AMENDMENT OF SOLICITATION			1. Contract Number		Page of Pages		
					1	1	
2. Amendment/Modification Number M0002		3. Effective Date 08/07/07		4. Requisition/Purchase Request No.		5. Solicitation Caption Renovation & Modification of Engine Company No. 29

14. Description of Amendment/Modification (Organized by UCF Section headings, including solicitation/contract subject matter where feasible.)							
<b>The following three (3) line items for the Renovation &amp; Modernization of Engine Company No. 29 are hereby amended as follows:</b>

Project Number LD2-37  
Complete Renovation and Modernization of Engine Company Number 29  
Solicitation Number DCFB-2007-B-0067  
(Q) & (A)

INTERIOR WINDOW TRIM @ EXT. WALL

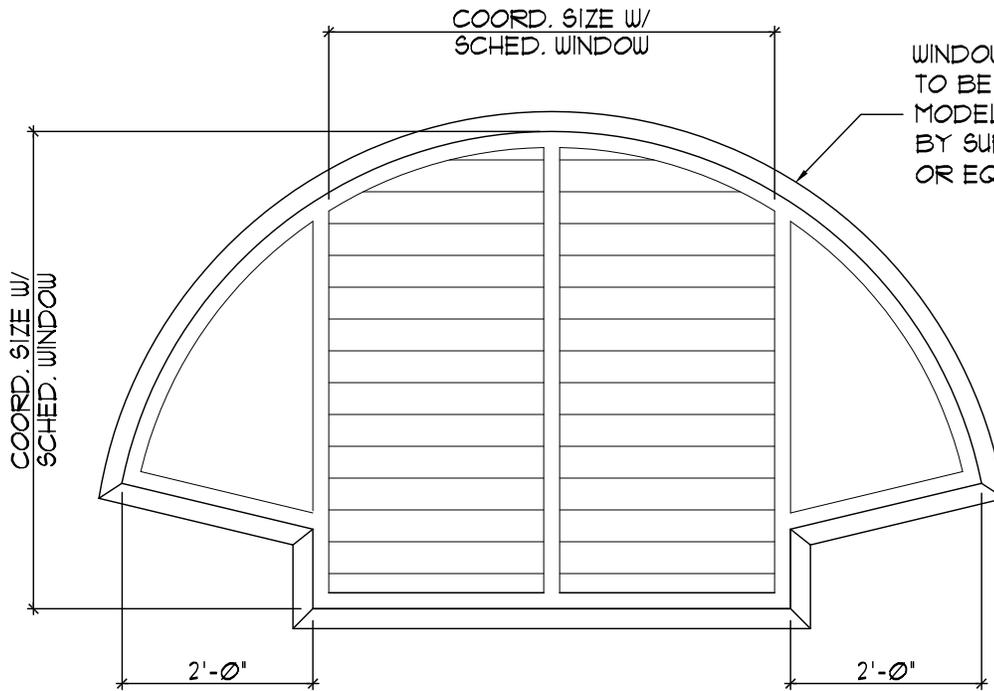
19) (Q) Window schedule A7.3 shows window E1 to E7 without any sill, jamb, and header details. What is the sill? jamb, and header details of these windows? Please clarify.

(A) -At all new exterior windows in the existing exterior wall construction provide wood trim and castings as identified on attached sketch number Amend. 1

WINDOW CASINGS & APRONS  
 TO BE 5/8"x2 1/2" PINE,  
 MODEL #PC1-24 AS MANUFACTURED  
 BY SUPERIOR MOLDING 1-800-473-1415  
 OR EQUAL. ALL TO BE PAINTED.

1. PROVIDE 1x PINE CASING FROM WINDOW FRAME TO FACE OF FINISH WALL, TYP. @ PERIMETER
2. ALL WINDOW TRIM TO BE PAINTED TO FACE OF FINISH WALL, TYP. @ PERIMETER

# CANTILEVER RETAINING WALL

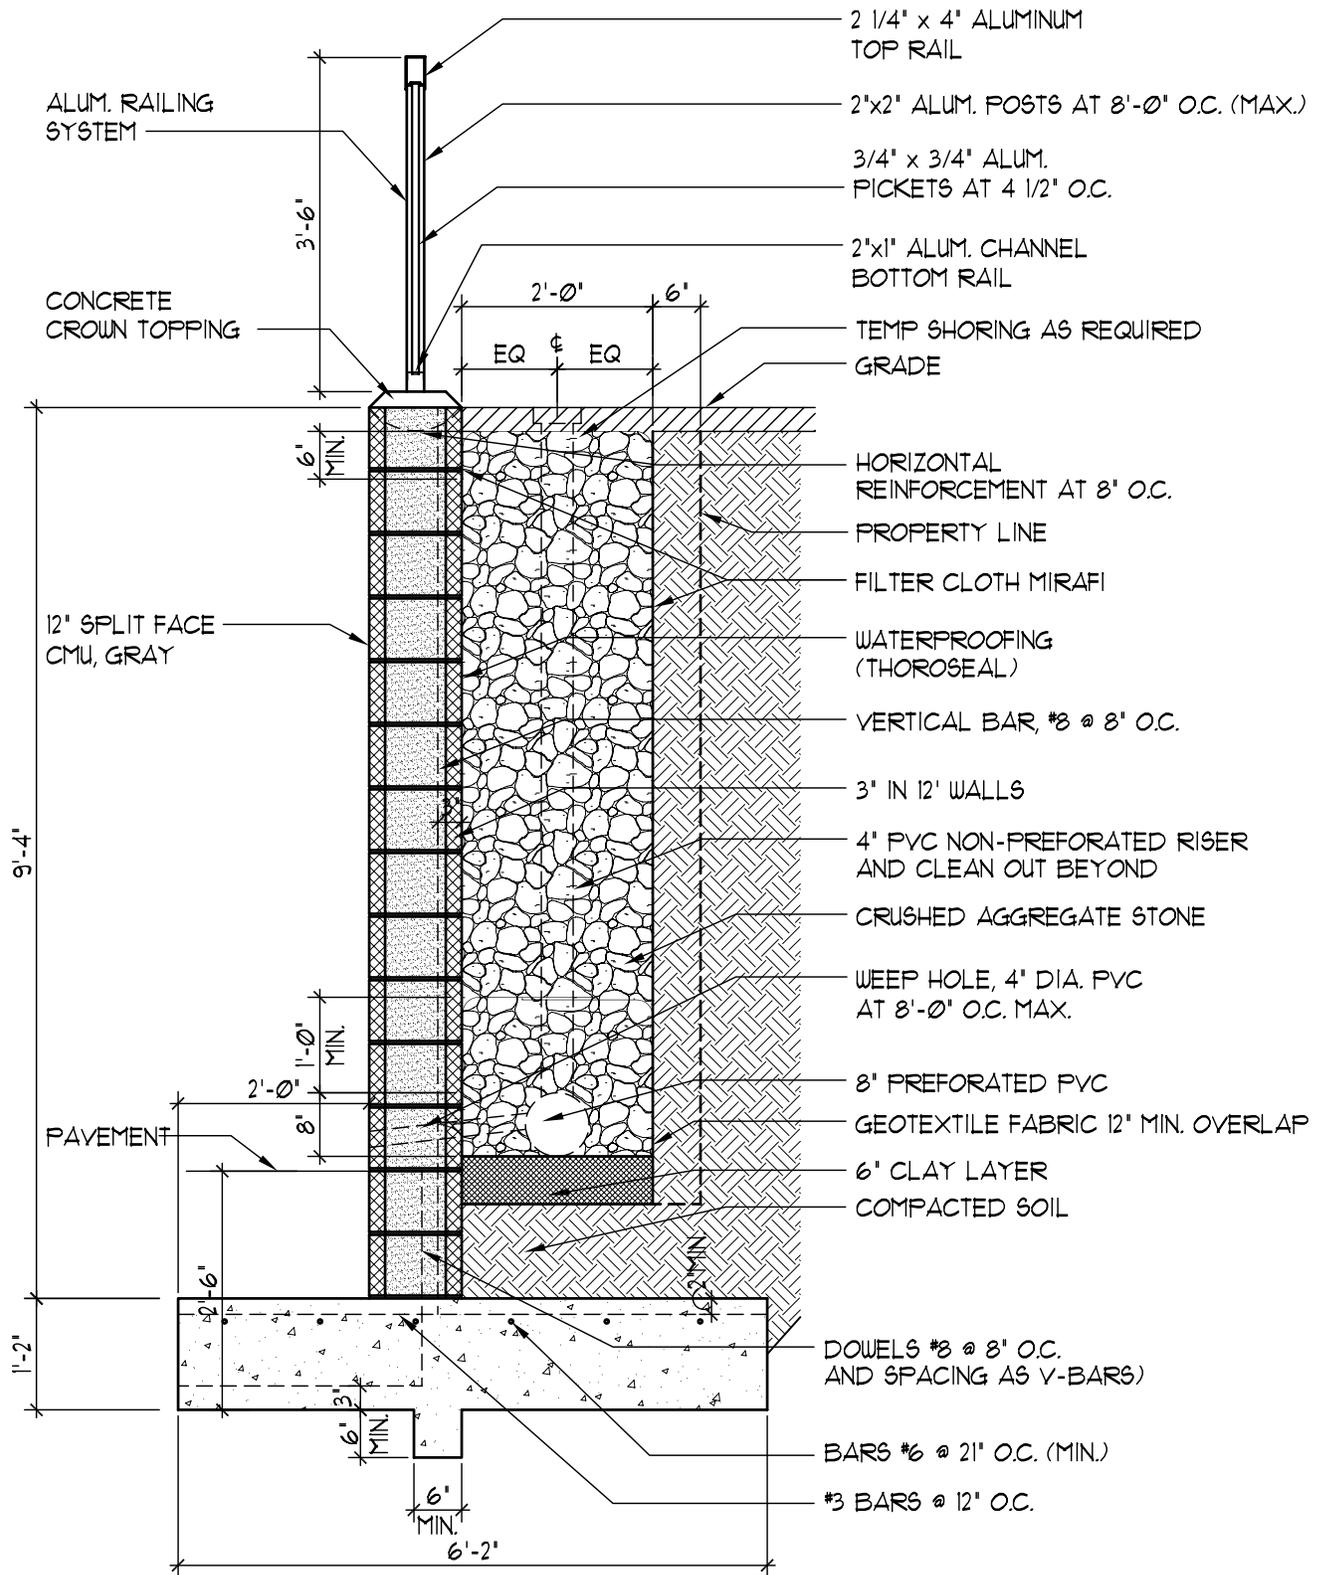
15) (Q) Drawing C4.0 shows retaining wall with guard rails. It also cross-references with the structural drawings. However, there aren't any reference details, elevations, or specification sections for these works. Please, provide appropriate drawings and specification sections for retaining wall and guard rails.

(A) - See attached new sketch number Amend number 4.

PROJECT NAME: ENGINE COMPANY #29  
PROJECT NO.: SUBJECT: CANTILEVER RETAINING WALL  
DESIGNED: B5Z DATE: 8-3-2007  
REFERENCE SHEET: C40 SHEET OF
